MODIFICATION OF SAMPLING METHOD FOR TMDL RECEIVING WATER SITE UPPER SAN GABRIEL RIVER COORDINATED INTEGRATED MONITORING PROGRAM

The proposed modification affects CIMP Section 9.1, Section 12, Table 12-1, and Attachment B (see Enclosure for exact revised pages of the CIMP in track changes).

B-1.3 San Gabriel River Reach 4 TMDL Site

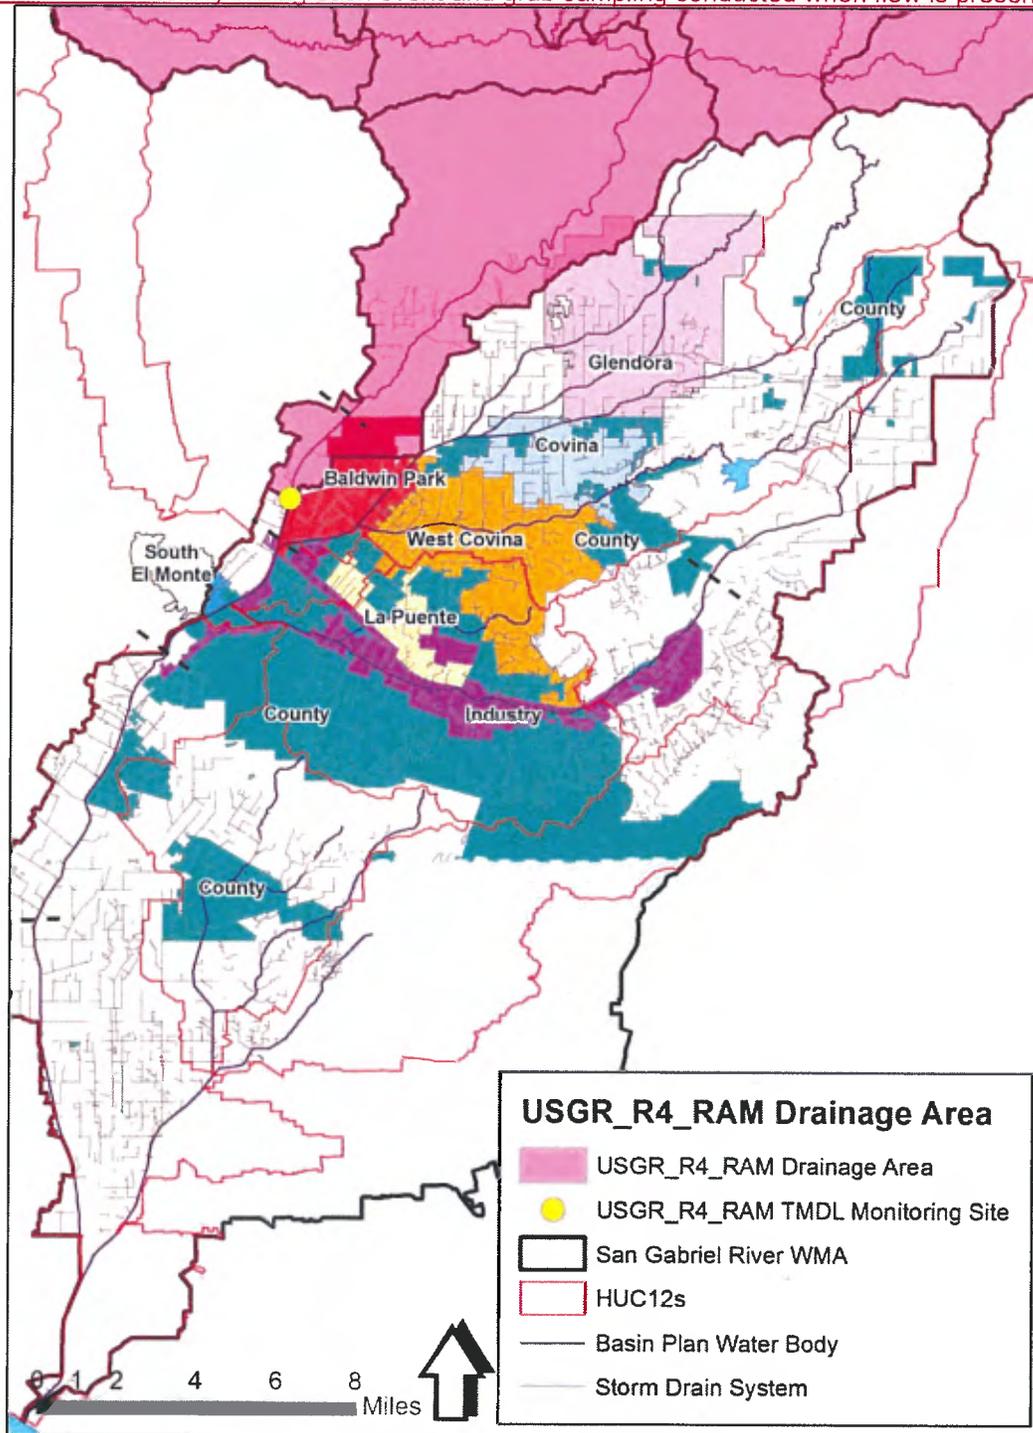
General Description: TMDL monitoring site located in San Gabriel River Reach 4 at control structure just downstream from Ramona Boulevard. An autosampler will not be installed due to no observation of flow. The site will be observed visually during each event and grab sampling conducted when flow is present.
